May 25, 2000

FROM: Shri Mohan
Hydrogeologist 3, Nuclear Waste Program

SUBJECT: 300-FF-2 Operable Unit (OU) Uranium Groundwater Contamination

Hanford Environmental Information System (HEIS) Uranium Data Review

Well 399-2-2

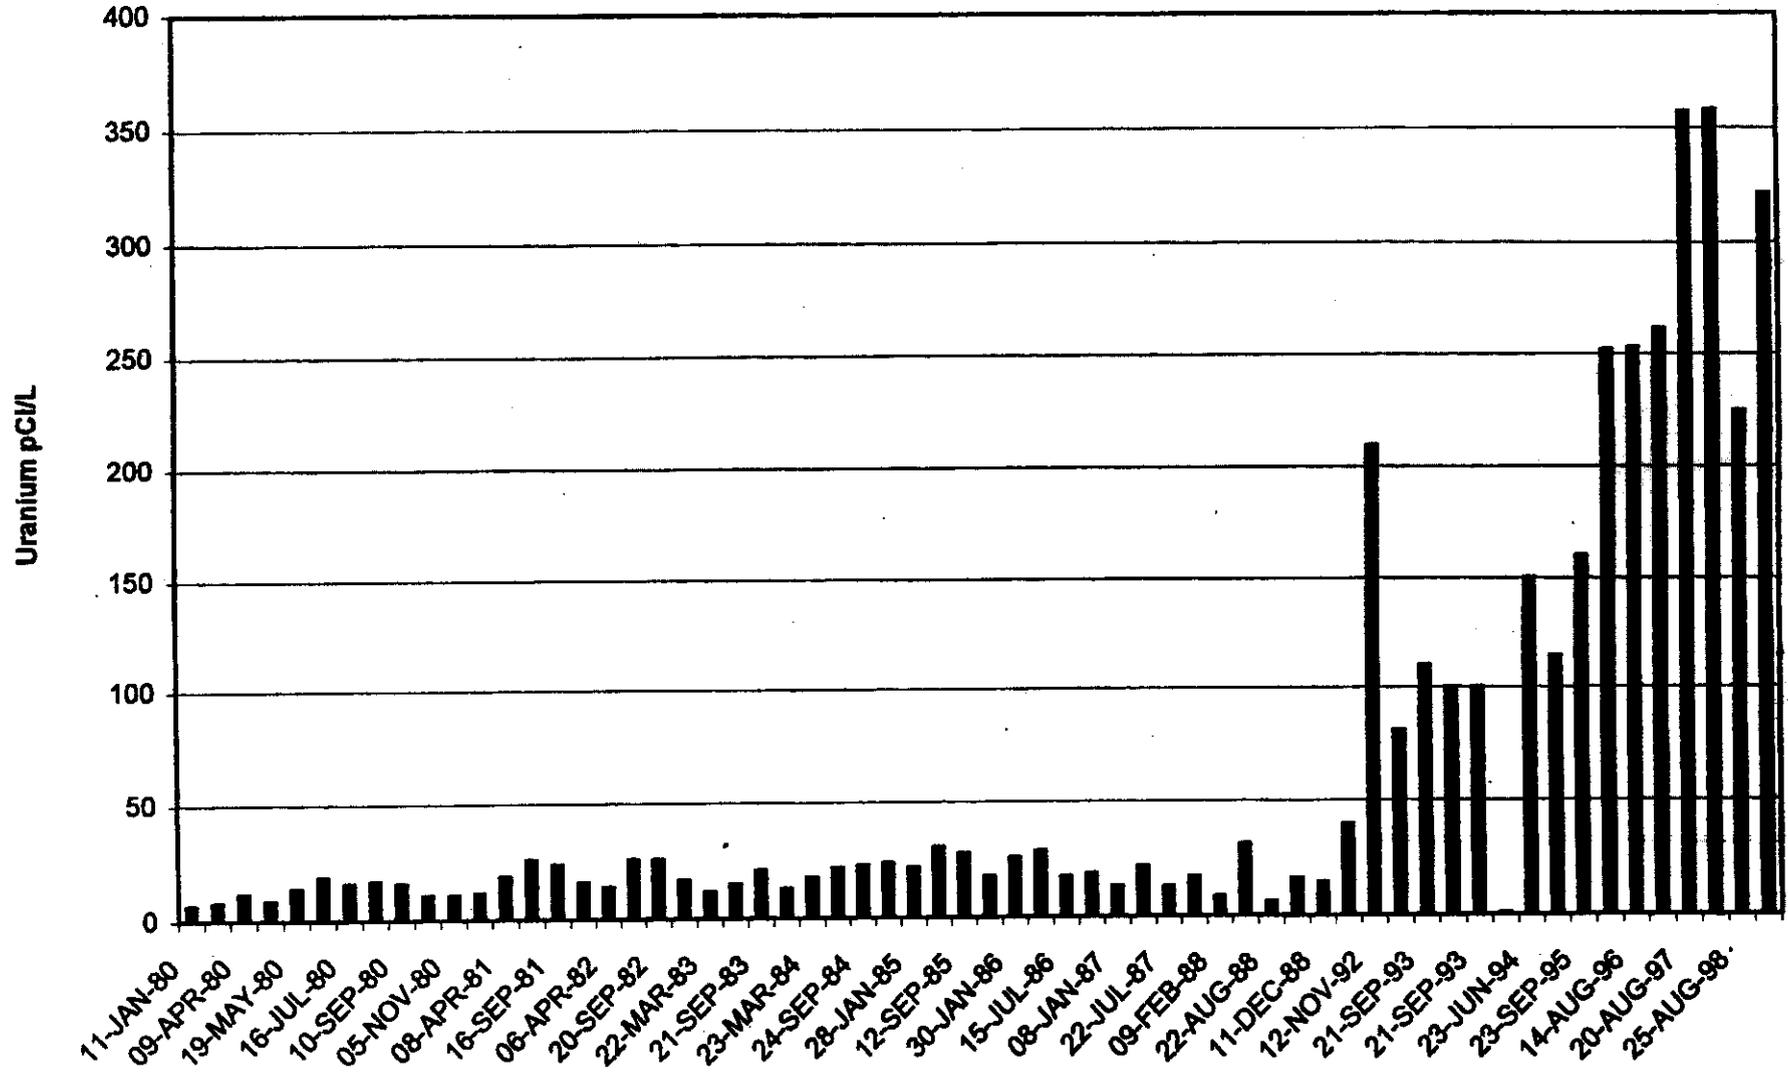
- Uranium concentrations have not decreased as predicted. See plots from wells 399-2-3, 399-2-2, 399-1-5, 399-1-4, 399-3-10, 399-2-1, 399-1-2, 399-3-3, 399-3-2, and 399-3-6.

- Wells 399-2-2, 399-2-3, 399-3-1, 399-3-9 and 399-3-10 are located north to south along the river shoreline. The trend plots show gradual increasing uranium concentrations in all these wells. The increasing trend is seen beginning around the year 1990 and has been increasing since. The maximum concentration of uranium in the north most well 399-2-2 is about 350 pCi/L and the southern well 399-3-10 is about 90 pCi/L. All these wells fall within the 300-FF-5 uranium plume. All these wells are very close to the river and it can be easily concluded that the contaminant has been polluting the river for many years.

Well 399-3-6

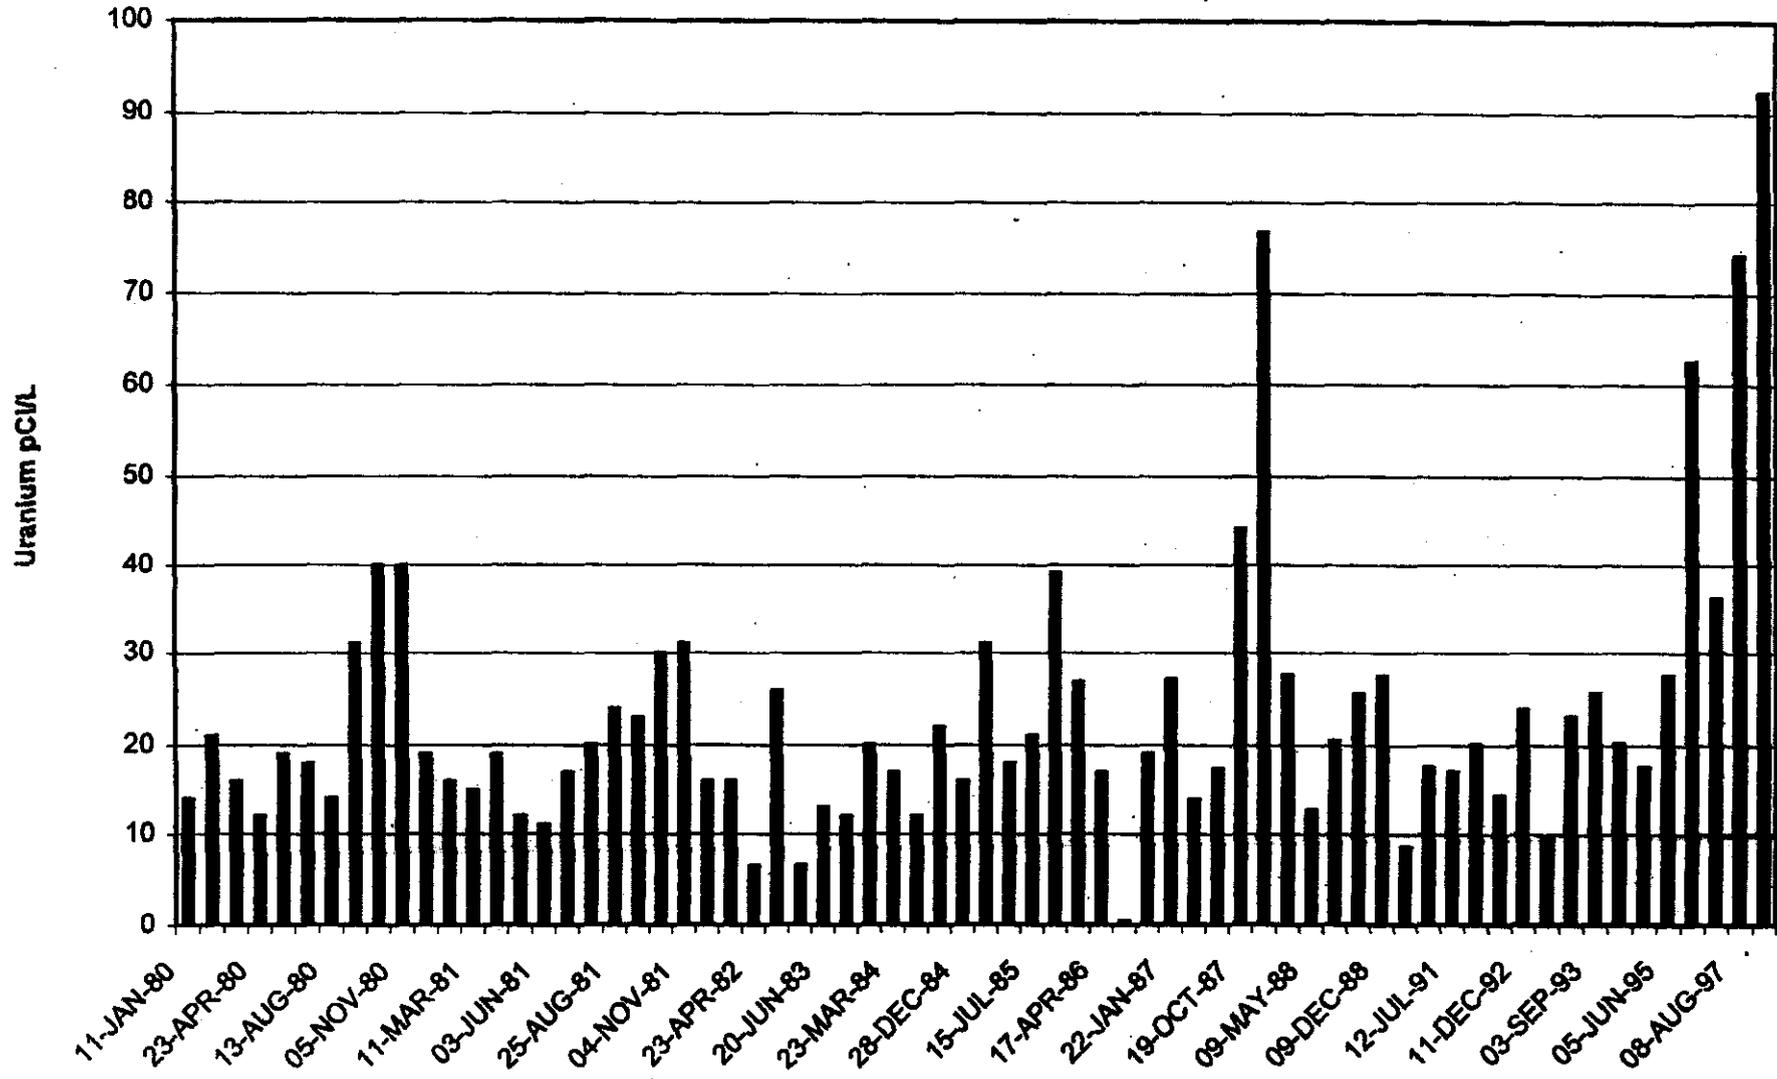
- Wells 399-3-6, 399-3-2 and 399-3-3 are located on the southern part of 300-FF-1 area and are outside the boundary of the uranium plume. There is no specific trend of the uranium concentrations on these wells. However, the concentrations of uranium have been periodically up to approximately 40 pCi/L. Some external source seems to be impacting the uranium concentrations of these wells.

Well 399-1-2

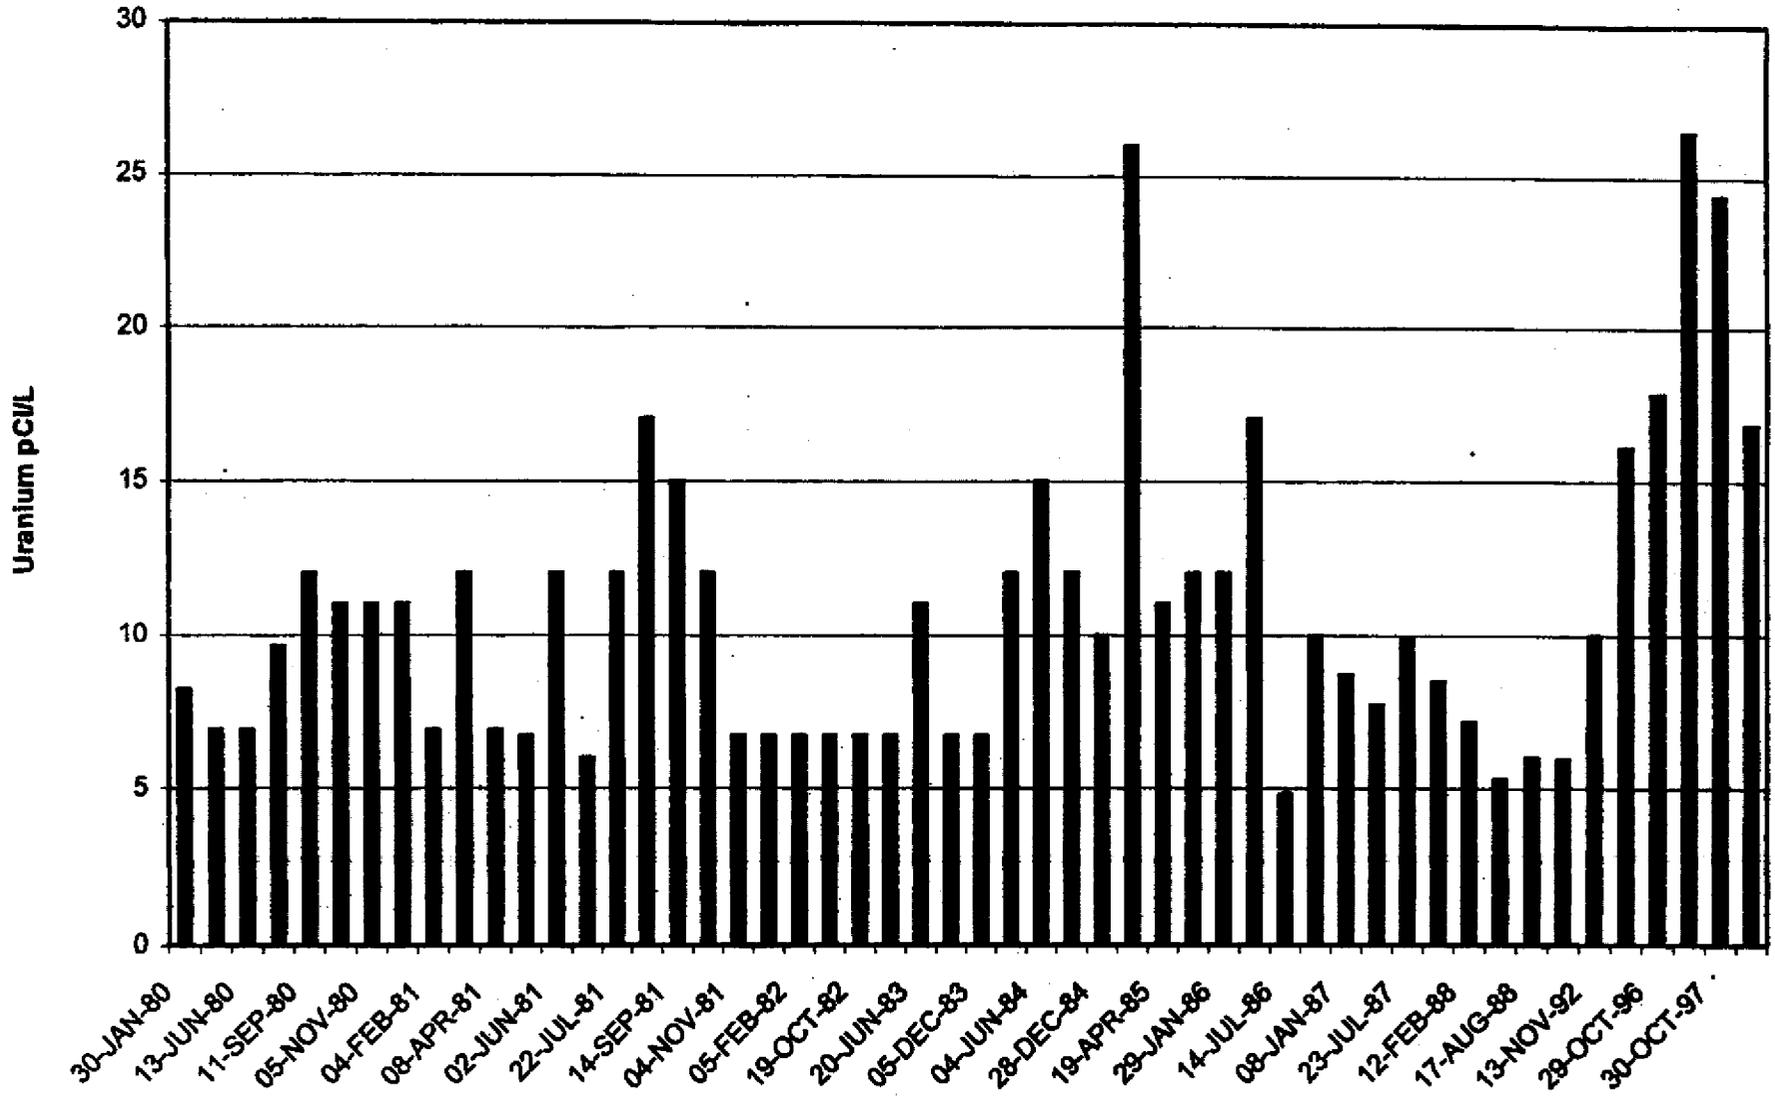
- Wells 399-1-2, 399-1-4 and 399-1-5 have also been plotted for uranium trends. These wells are located within uranium plume and are on the western edged of 300-FF-1 operable unit. Well 399-1-5 shows a definite increasing trend of uranium since about 1992, the maximum concentration being about 180 pCi/L. The other two wells, 399-1-2 and 399-1-4, indicate concentrations in the range of 20 to 50 pCi/L since the beginning of observations. The impact on these wells could be from the source sites in the vicinity of the wells.
